June 7, 2021

**Subject: RFQ #1961-A: Water System Admin Building Renovation
Addendum #2**

Attachment 1

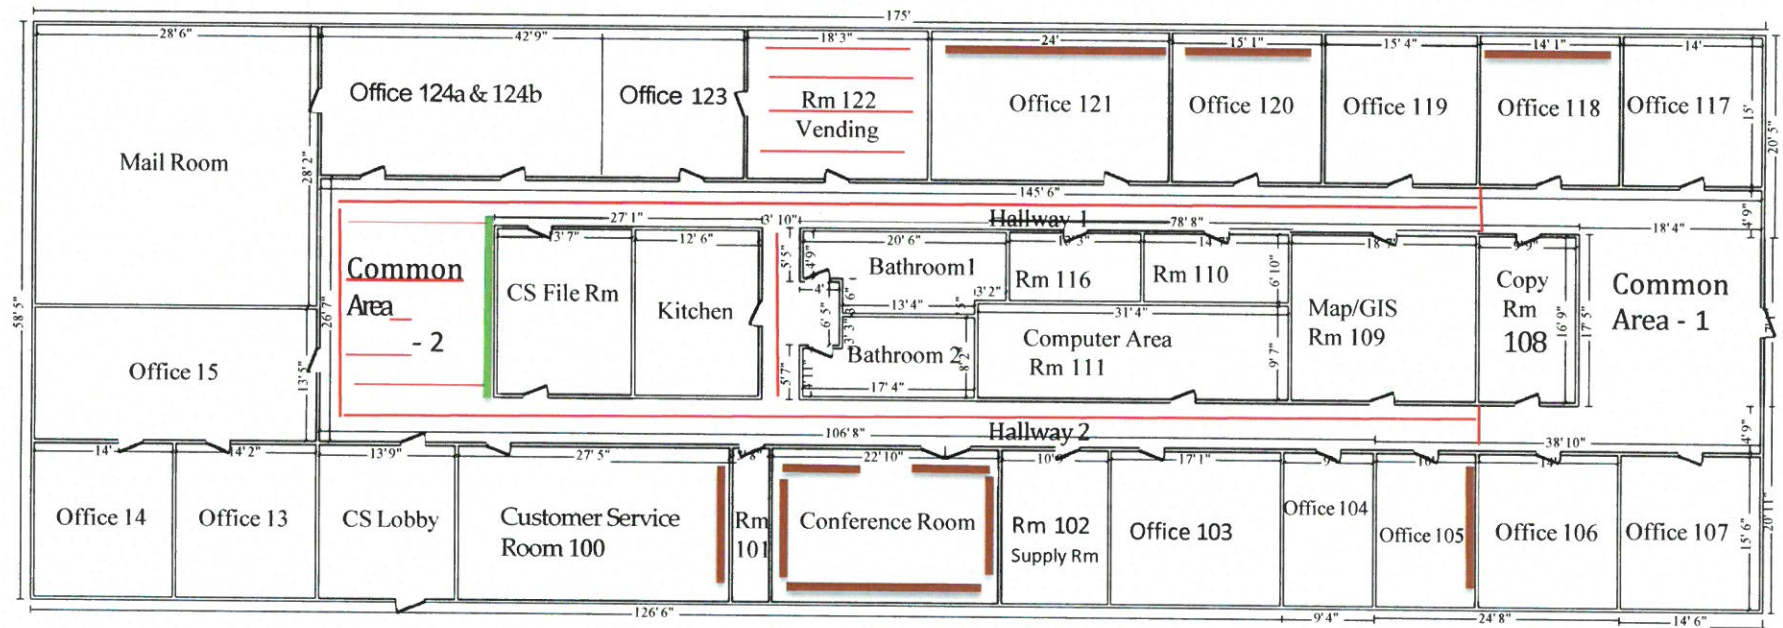
1. **The layout provided in the original RFQ has been updated and is attached. (Attachment 1) The layout illustrates the following:**
 - a. Walls receiving accent paint are marked in brown.

- b. Rm. 22 Vending is marked with red lines to indicate vinyl flooring shall be installed.
 - c. The GREEN highlight in Common Area 2 indicates that the wall between the Common Area and the CS File Room shall not be painted.
